Service Bulletin

Bulletin Number: **SB-18-300**
Release Date: **October 5, 2018**
Subject: **2014-2018 Service Hoist/Service Lift Units: Rear Pivot Pin Assemblies**
Distribution: **Affected Customers, End Users, Key Accounts, Dealers, Customer Service, Field Service**

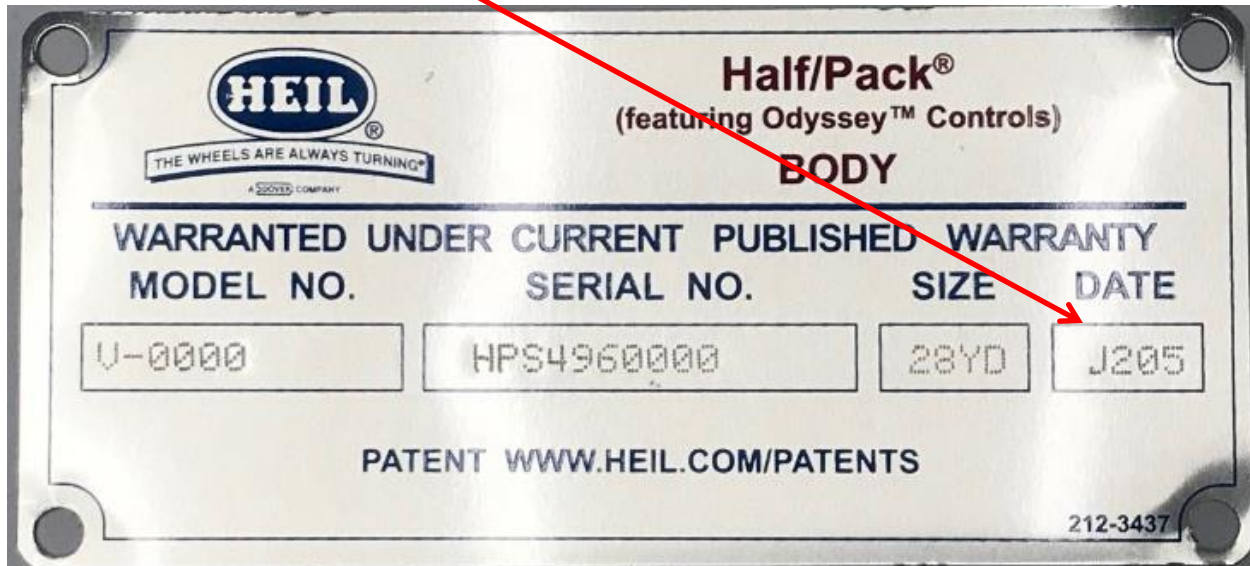
The potential defect relates to off-spec welding of the Rear Pivot Pin Assemblies, Heil P/N 211-5256. These 2 pins (one on each side of the frame rail) hinge the body structure during Service Hoist or Service Lift raising and lowering operations.

Accordingly, this Service Bulletin serves as a mandatory directive from Heil to cease utilization of the Service Lift and Service Hoist to raise the body until inspection and/or repairs have been completed.

Utilizing the Service Hoist or Service Lift may cause the raised body to become unstable.
